40 CFR Part 63

National Emission Standards for Hazardous Air Pollutants for Source Category: Pulp and Paper Production

ACTION: Proposed rule amendments and notice of public hearing.

Figure 1. Proposed Changes to Daily Monitoring Requirements for Open Biological Treatment Systems

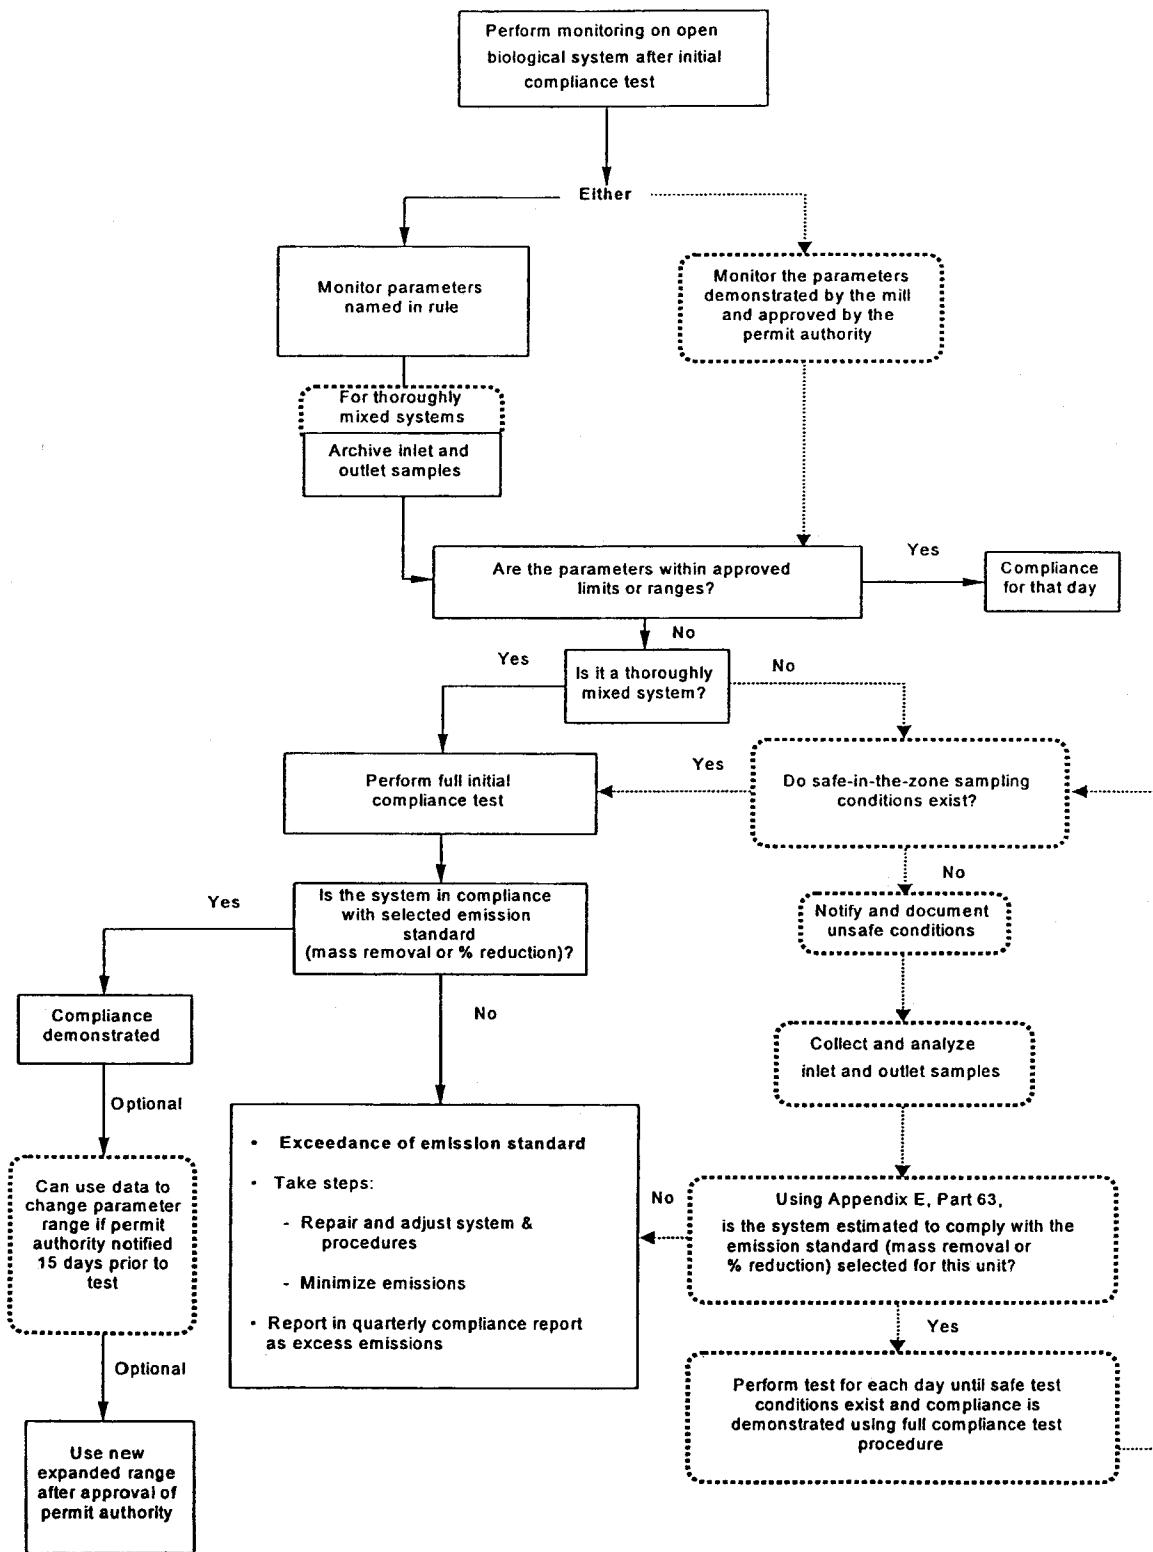
The flow diagram shown in figure 1 summarizes the daily monitoring

requirements for open biological treatment systems. In figure 1, today's proposed changes are depicted by dashed lines and rounded boxes.

(Dotted lines denote proposed changes)

Mills must monitor on a daily basis either the parameters specified in the final rule (§ 63.453(j)(1)) or site-specific parameters that have been approved (proposed § 63.453(j)(2), see section I.E.2 of this preamble). If the monitoring parameters are within the values or ranges established during the initial performance test, compliance with the applicable emission standard is demonstrated for that day. If the monitoring parameters are outside the established values or ranges, you must conduct a performance test to confirm compliance of the open biological treatment system. The performance test must be performed using the same procedures (*i.e.*, the appropriate procedures in appendix C of part 63) that were followed during the initial performance test.
